Application of Rohail Hada for a Special Land Use Permit (SLUP) to allow an accessory alcohol outlet Tier 1 of the Bouldercrest Overlay District and in the C-1 (Local Commercial) zoning district, at 2510 Bouldercrest Road.

PETITION NO: N11-2026-1270 SLUP-26-1248269

STAFF ANALYSIS

CASE NO.:	SLUP-26-1248269	**File ID #:** 2026-1270
Address:	2510 Bouldercrest Road, Atlanta, GA 30316	**Commission Districts:** 03 and 06
Parcel ID(s):	15 077 02 011	
Request:	Application of Rohail Hada for a Special Land Use Permit (SLUP) to allow an accessory alcohol outlet (beer and wine sales) in the C-1 (Local Commercial) zoning district and Tier 1 of the Bouldercrest Overlay District.	
Property Owner(s):	Rohail Hada	
Applicant/Agent:	Rohail Hada	
Acreage:	1.066	
Existing Land Use:	Vacant convenience store and fuel pumps	
Surrounding Properties:	**North:** Forested land, recreational land, and a single-family detached subdivision **East:** Clifton Church Road separates subject site from a shopping plaza **South:** Bouldercrest Road **West**: Bouldercrest Road separates the subject site from multi-family apartment complex	
Adjacent Zoning:	**North:** MZ (Multiple Zoning), R-75 (Residential Medium Lo

13
2
4
Candace Way
Clifton Church Rd
468.43 ft
Boulder crest Rd
2516
18

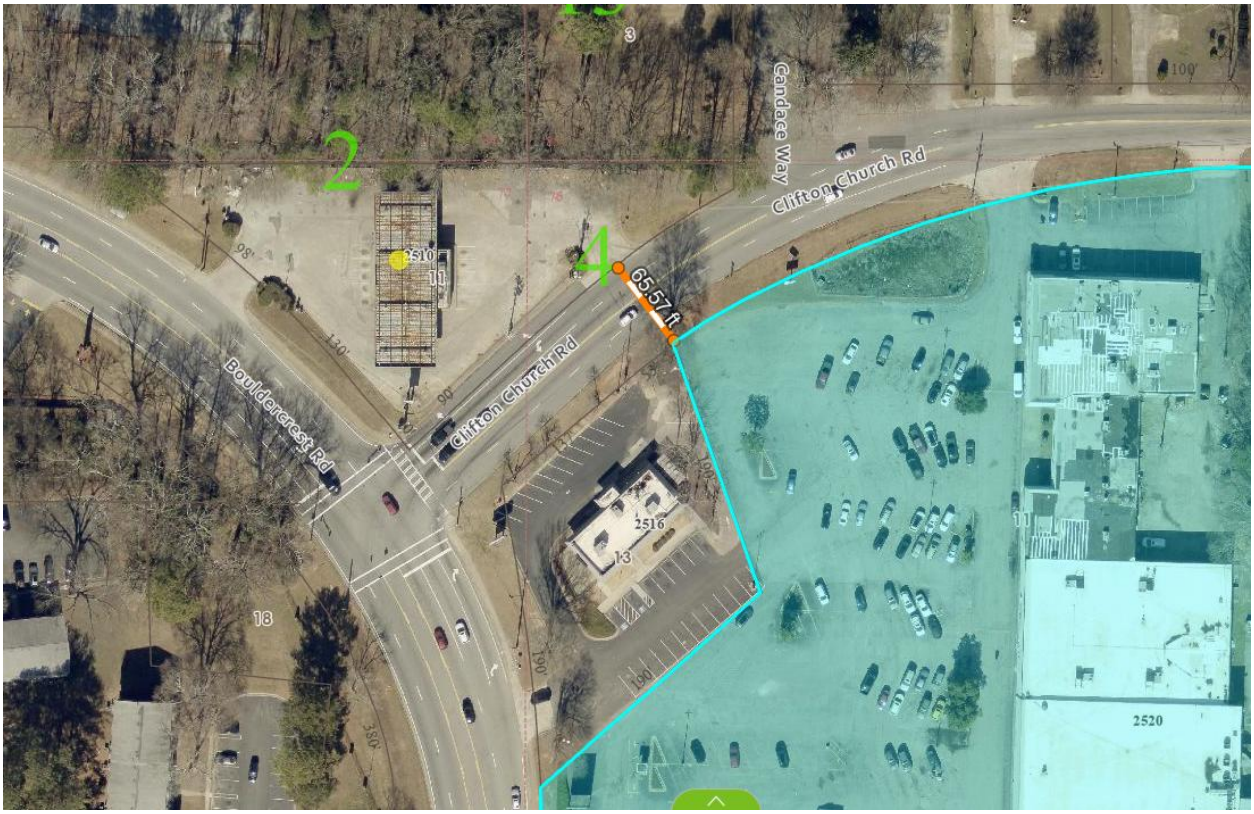
The site's irregular shape and frontage along Bouldercrest Road and Clifton Church Road constrains the buildable area. Compliance with the Bouldercrest Overlay's streetscape, pedestrian access, and right-of-way requirements have not been demonstrated. The proposal appears to satisfy Supplemental Regulations in Section 4.2.8, subject to plan documentation confirming that alcohol sales and storage occupy no more than 20 percent of the gross floor area, as required by Subsection D. However, the proposal appears inconsistent with the Supplemental Regulations in Section 4.2.28(I), which requires 3,960 feet (three-fourths of a mile) of separation between a new convenience store and an existing small box retail discount store. A Family Dollar is located approximately sixty-five (65) feet away, across the street.

CONCEPT PLAN I FOR:
2510 BOULDERCREST ROAD
ATLANTA, GA 30316

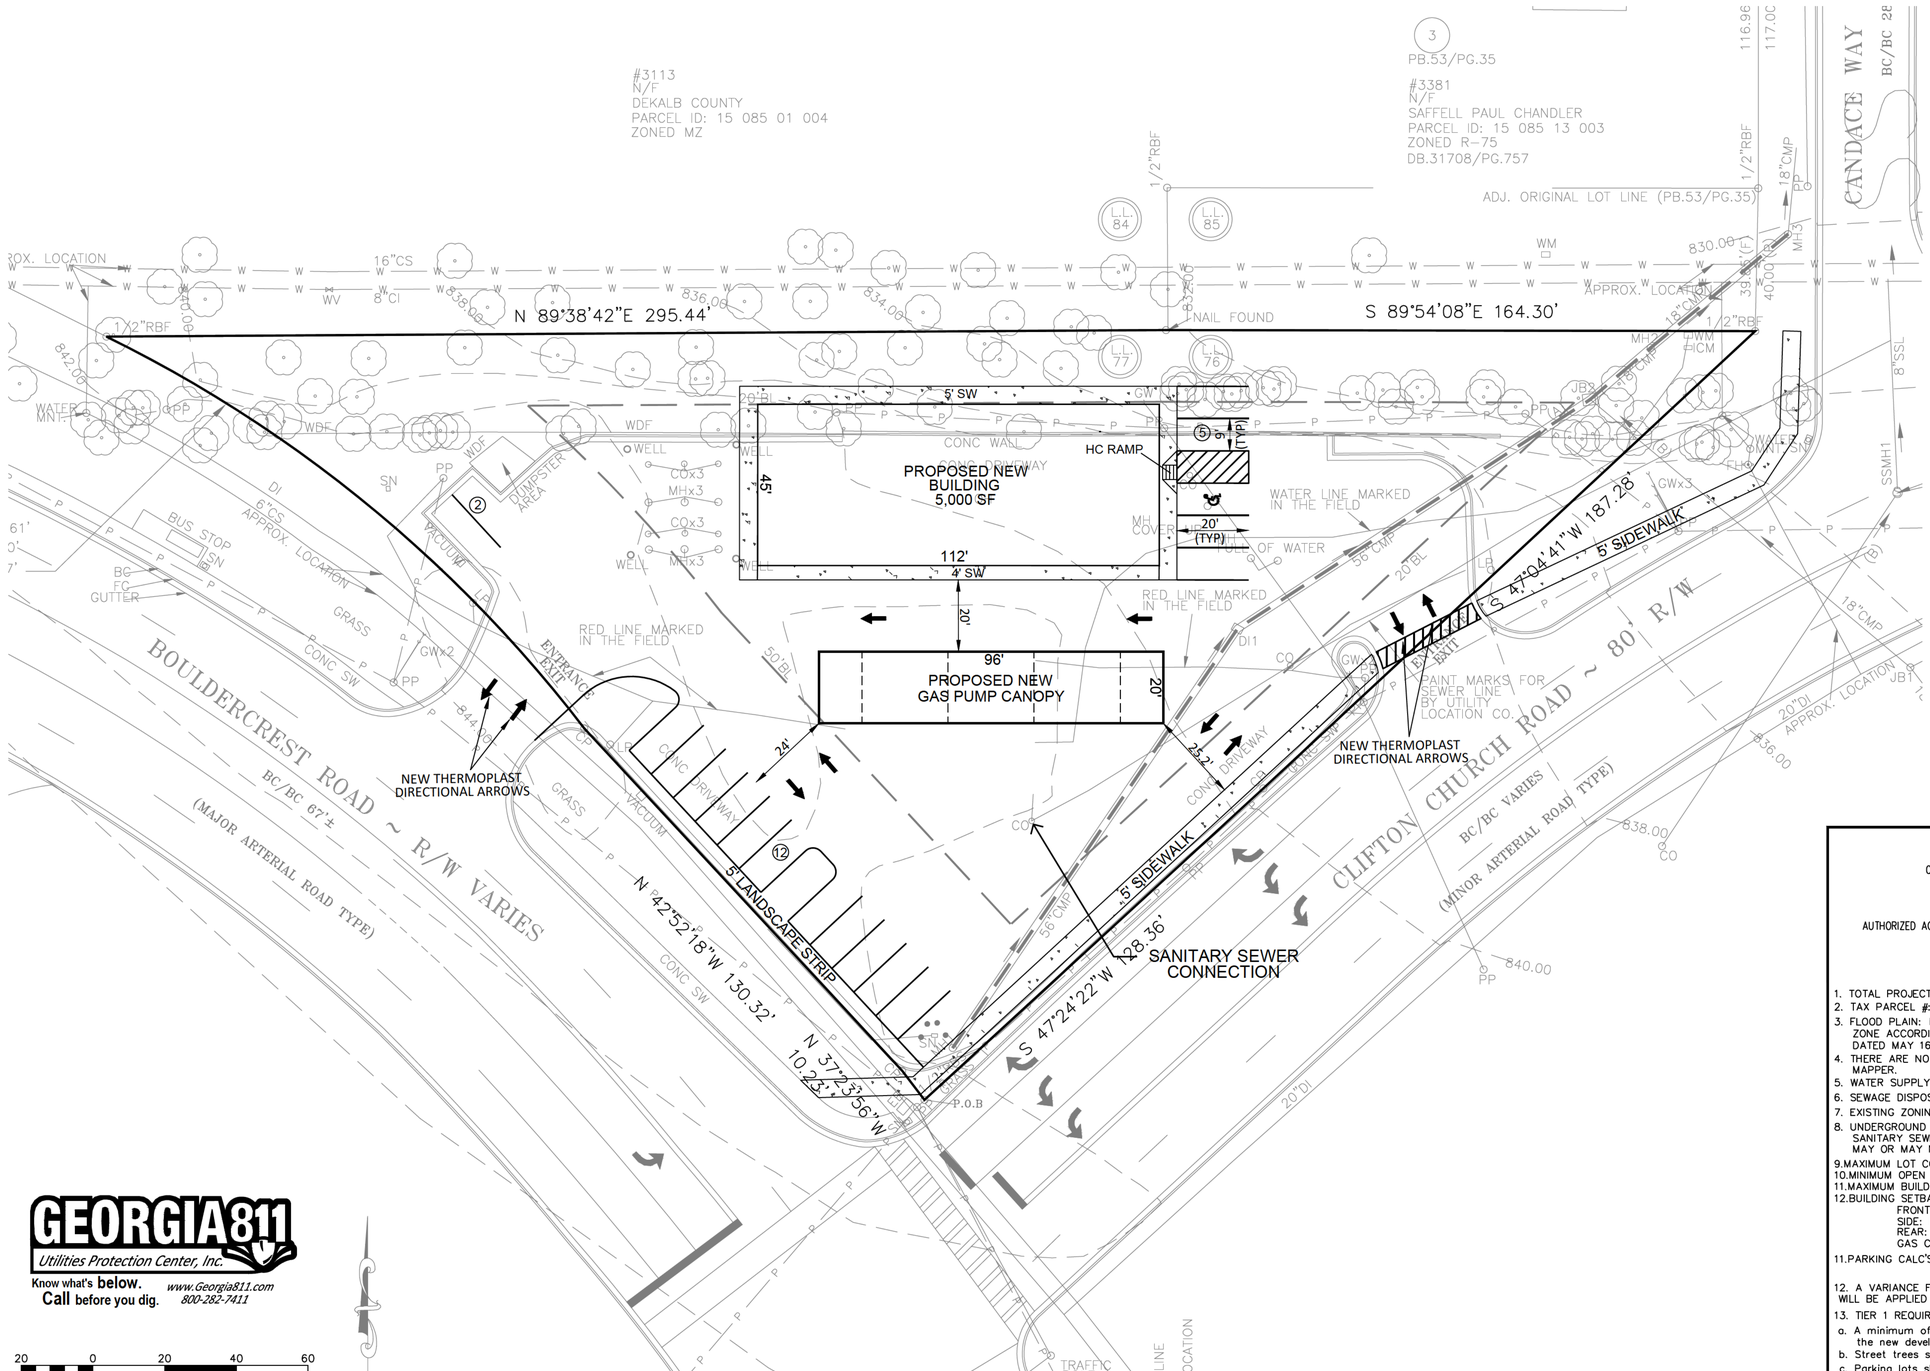
Staff identified several site plan deficiencies related to the Bouldercrest Overlay Standards (Section 3.39.6.- *Standards Applicable to all Tiers*). Subsections C.1 and C.2 require a 10-foot sidewalk, a 10-foot landscape strip, and trees spaced no more than sixty (60) feet apart. Additionally (if not already in place) a right-of-way dedication of seventy-five (75) feet from the centerline of roadway is required - all public infrastructure must be within the right of way. The proposed site plan "*Concept Plan I*" dated, 6/19/2026 shows only a 5-foot sidewalk and 5-foot landscape strip along Clifton Church Road and does not demonstrate compliance with the required tree spacing. Furthermore, convenient pedestrian pathways connecting street sidewalks to each building entrance, are required by Subsection C.4. Any proposed signage must comply with Subsection B and Chapter 21. No additional material concerns were identified by the Interdepartmental comments.

The proposed redevelopment consists of several deficiencies related to the Bouldercrest Overlay standards in Section 27-3.39.6, does not meet Section 27-4.2.28 I. (*No new convenience store shall be permitted within 3,960 feet (i.e., three-fourths of a mile) of any currently existing small box retail discount store.),* nor support the intended goals of a CRC. Based on review of all criteria under Section 27-7.4.6, Staff recommend that application SLUP-26-1248269 be ***"Denied"***.
